**USEPA COMMENTS ON FEDERAL FACILITY COMPLIANCE AGREEMENT
(FFCA) DELIVERABLES**

USEPA DOE-FN
100
COMMENTS

The United States Environmental Protection Agency (U.S. EPA) has completed its initial review of the Remedial Investigation/Feasibility Study (RI/FS) Work Plan and supporting documents for the Feed Materials Production Center in Fernald, Ohio. In general, the following deficiencies have been identified:

WORK PLAN, DECEMBER 1986

FIGURE 7 Uranium Levels in Soils Adjacent to the FMPC

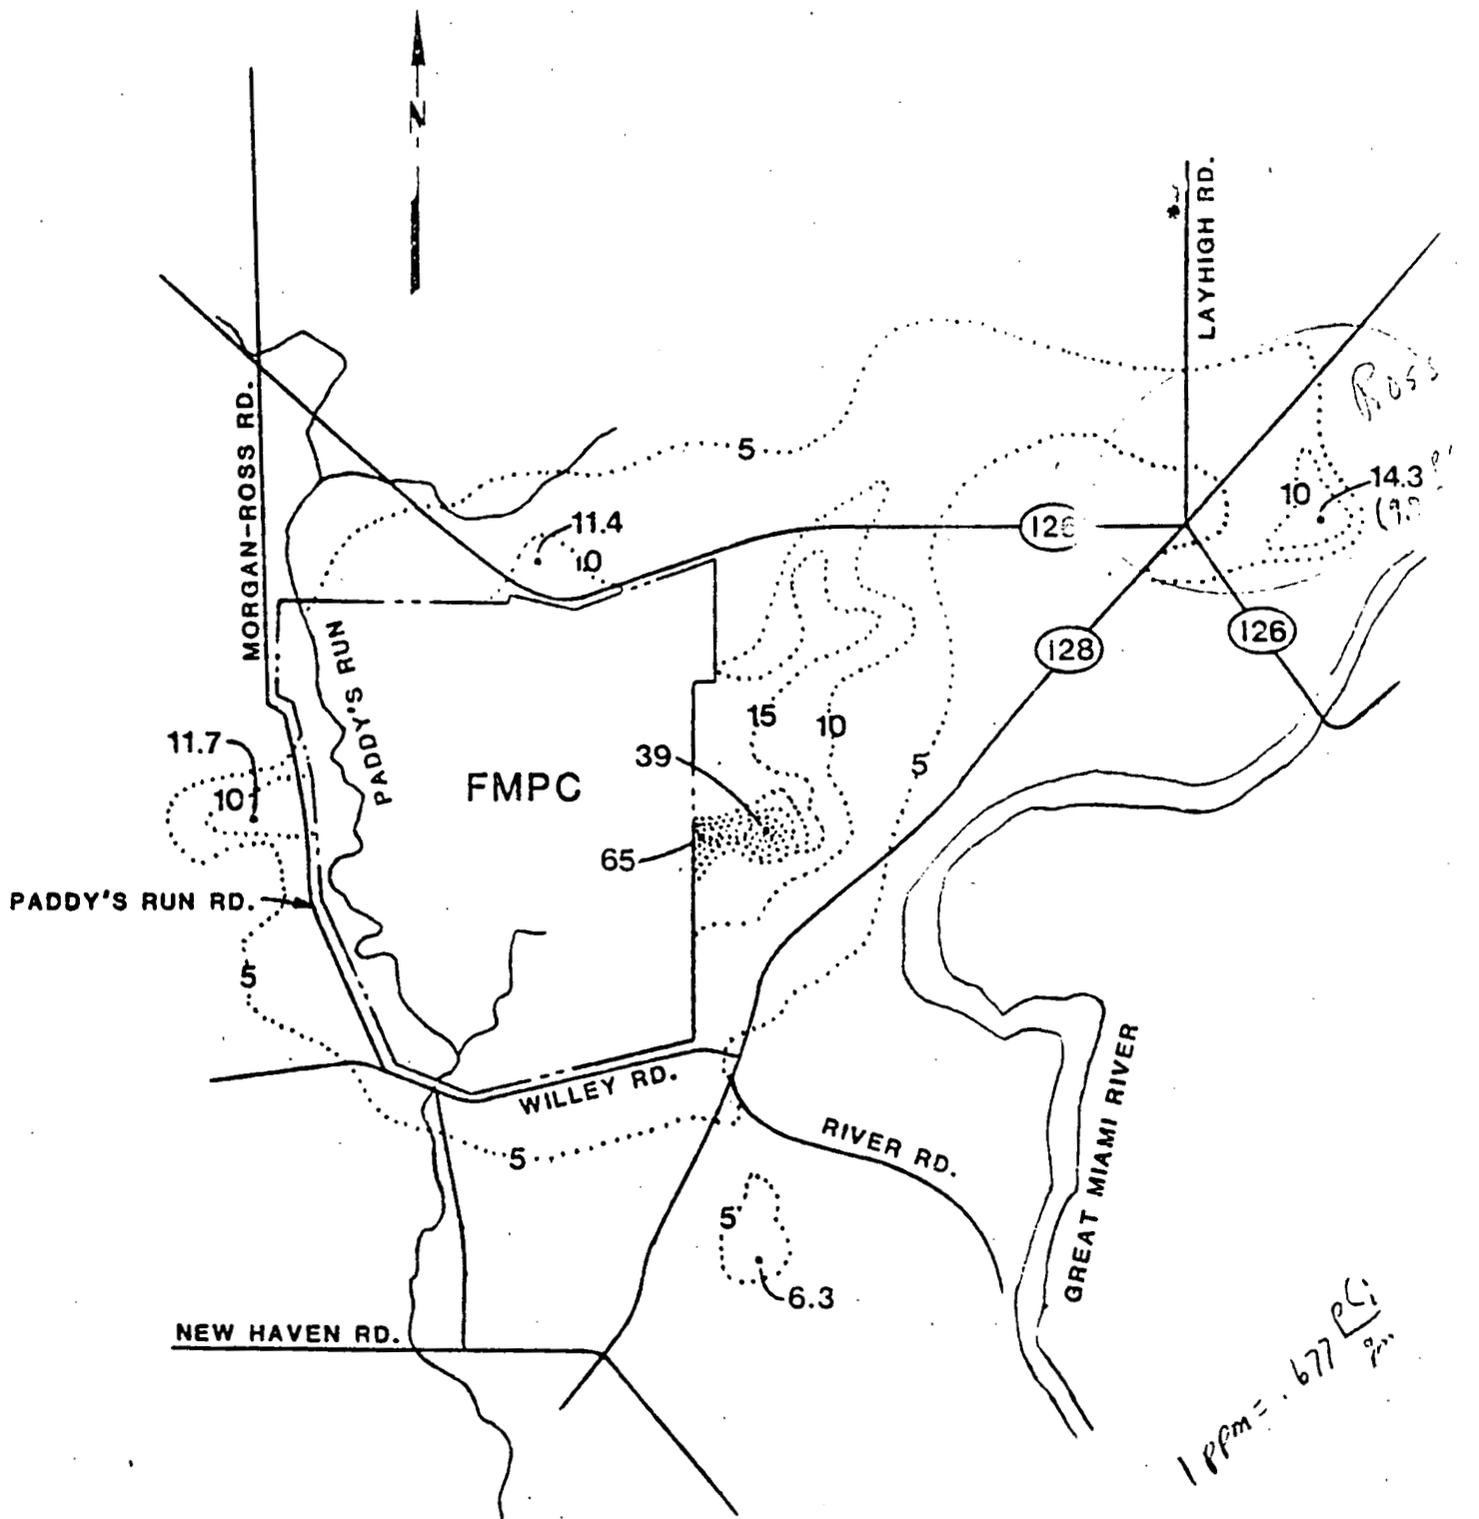
- Table 3.28, page 3-94 display sampling points 7, 10, and 27 to be close together as are points 13 and 26. We question why these are not grouped together with the results of sampling efforts. For the RI, soil and vegetation sampling points must be added at high uranium concentration sites identified in the 1985 Environmental Report (Figure 10, page 25).

FIGURE 4.6
SURFACE WATER AND SEDIMENT SAMPLING LOCATIONS

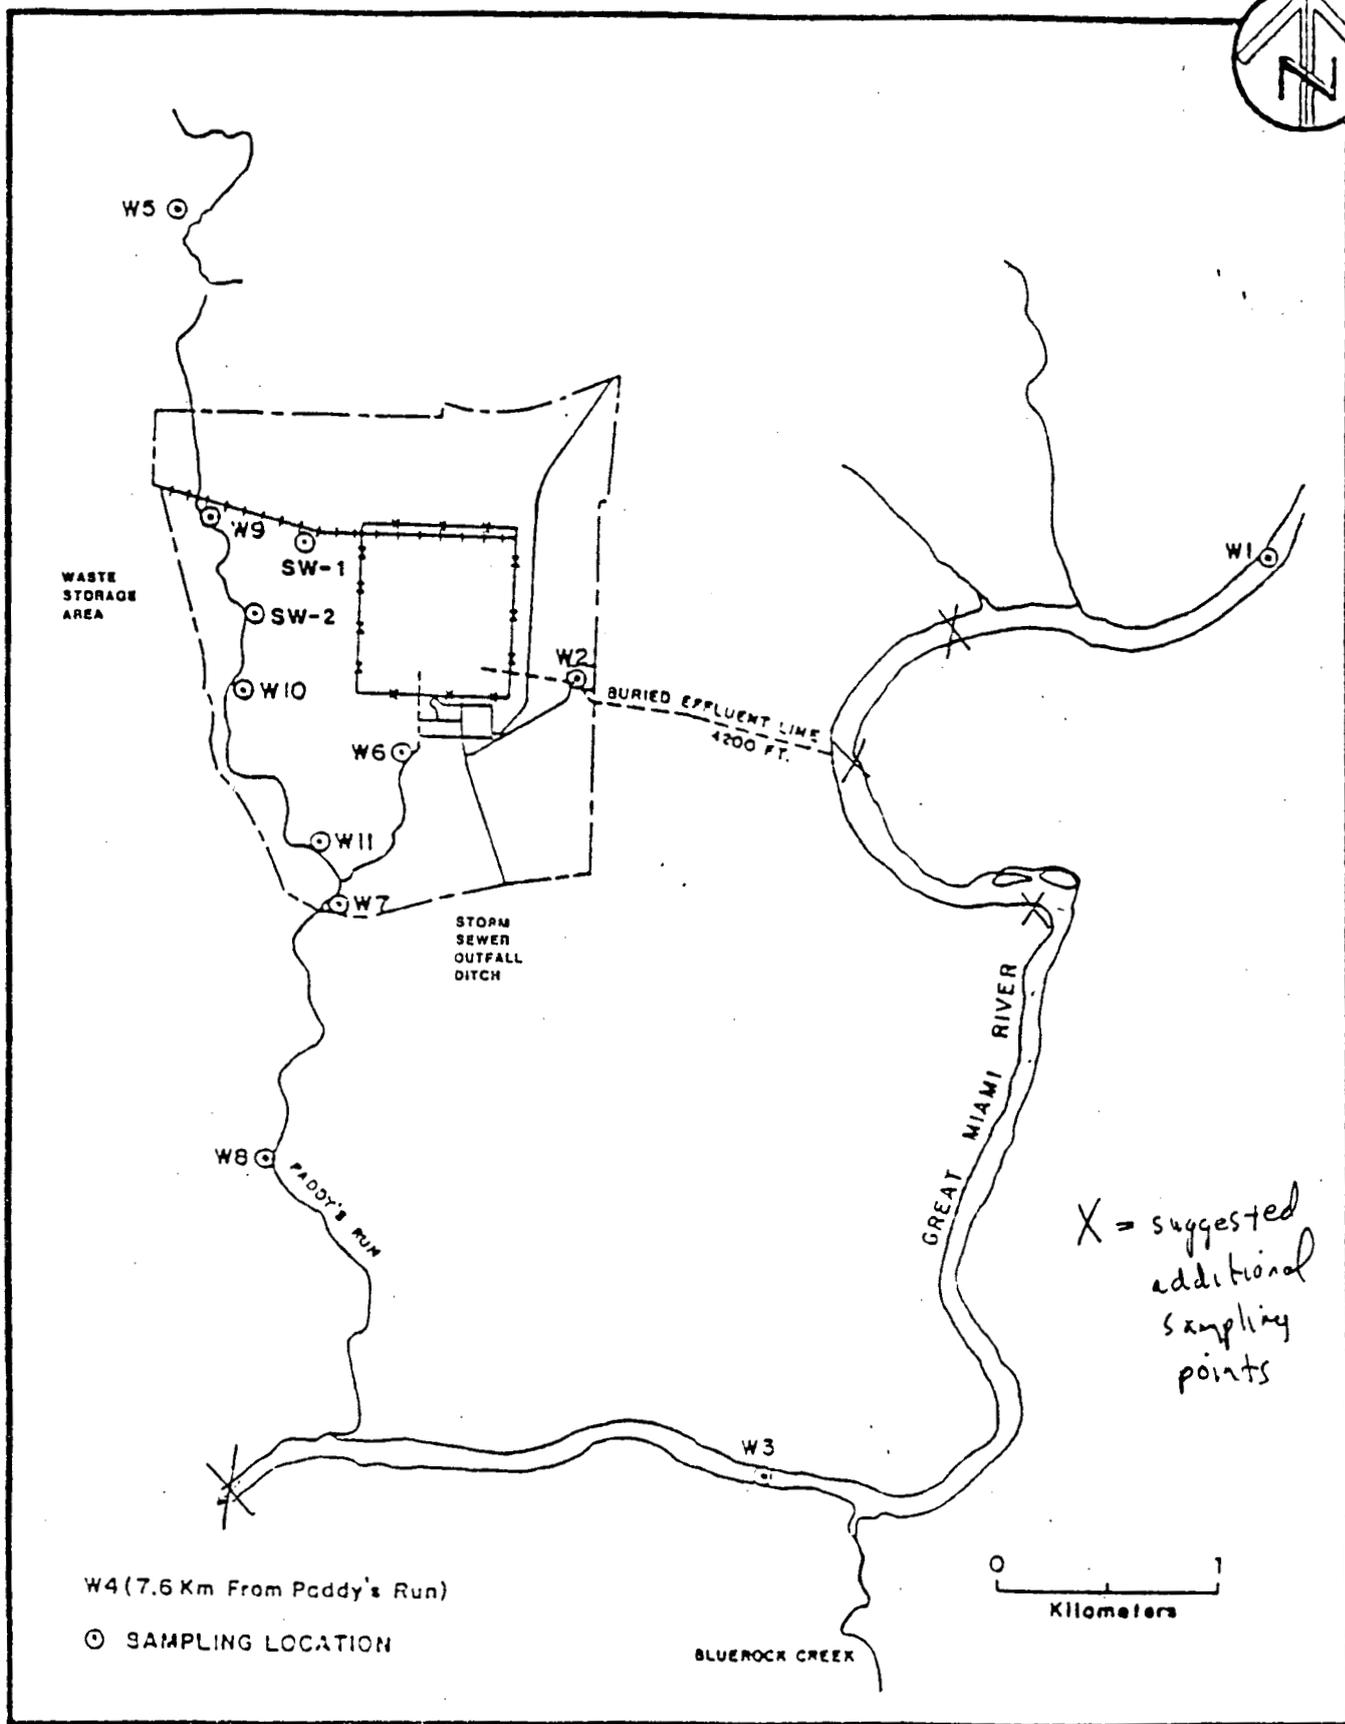
- Figure 4.6, page 4-20 displays an insufficient amount of sampling points along the Great Miami River. This sampling plan will not offer enough information about site problems. We suggest adding the sites shown on Attachment 3.
